Technical Service Information

THM 4L60 (700-R4) SOFT UP-SHIFTS

Figure 1

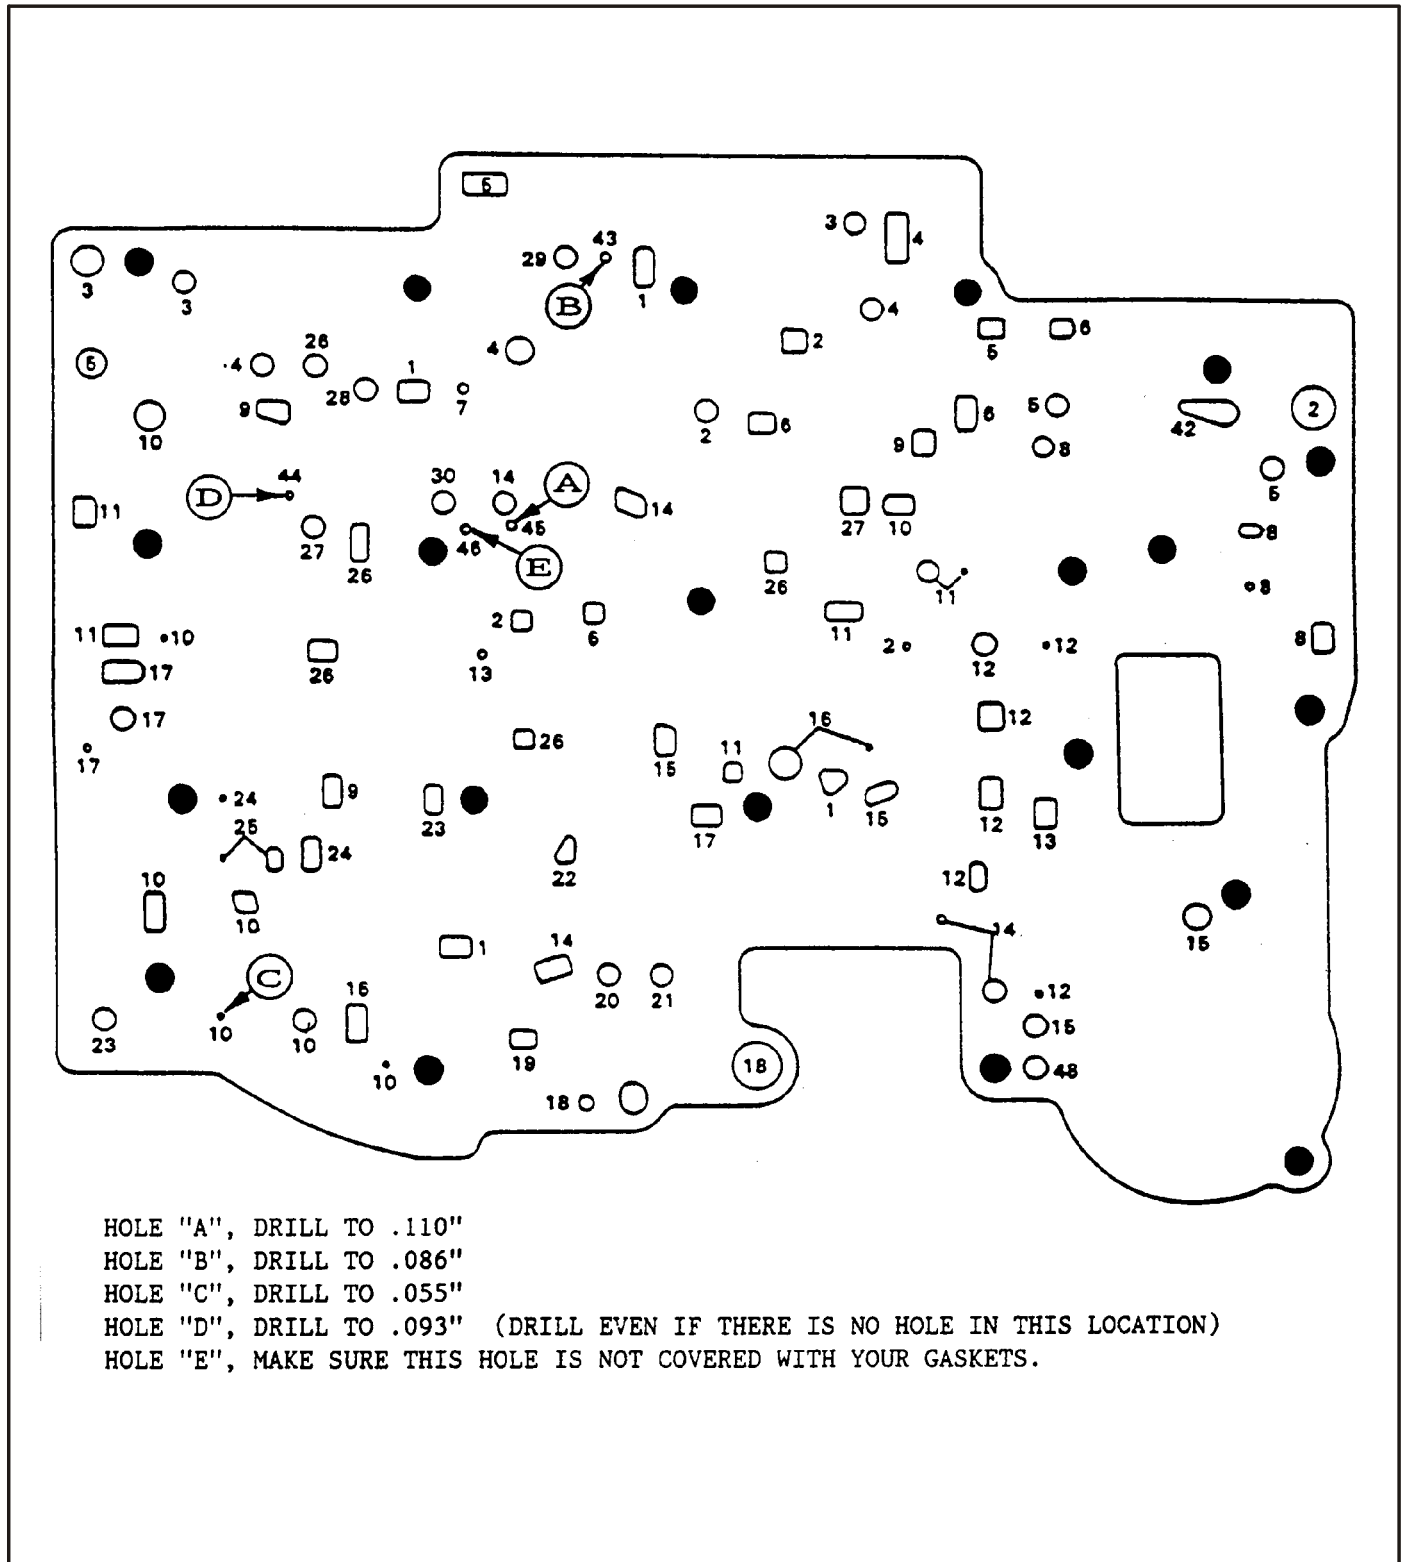
COMPLAINT: Soft and/or mushy up-shifts regardless of throttle position.

CAUSE: Not enough feed oil to the 2-4 band, and the 3-4 clutch pack.

CORRECTION: Drill the holes in the spacer plate, as shown in Figure 1, as follows:

HOLE "A", DRILL TO .110".
This will improve the 1-2 shift.

HOLE "B", DRILL TO .086".
This will improve the 2-3 shift. DO NOT drill any larger than .086" as a larger hole will create a flare on the 2-3 shift on some models.

HOLE "C", DRILL TO .055".
This will prevent the T.V. valve from hydraulically locking.

HOLE "D", DRILL TO .093".
This will help prevent the 3-4 clutches from burning. This hole was eliminated on the 1988 and later 5.7L models. If your spacer plate does not have this hole, use the gasket as a template and drill it to .093".

HOLE "E", MAKE SURE THIS HOLE IS NOT COVERED WITH YOUR GASKETS.
If this hole is covered by the gaskets, it will create the following:

- (1) Shifts 1-3 in drive, after initial upshift pattern. First set of upshifts are normal, and will be again, after setting awhile.
- (2) Delayed (5 Seconds) 4-2, or 3-2 kickdown.
- (3) Delayed (5 Seconds) manual downshift from D3 to D2. (Stays in 3rd)
- (4) Binds in reverse, after upshifting to 3rd gear. Normal operation after setting for a while.
- (5) Binds in manual Lo, after upshifting to 3rd gear. Normal operation after setting for a while.
- (6) Results in burnt 3-4 clutch plates. They are usually wiped out on the road test, as this is the exhaust hole for the 3-4 clutch.
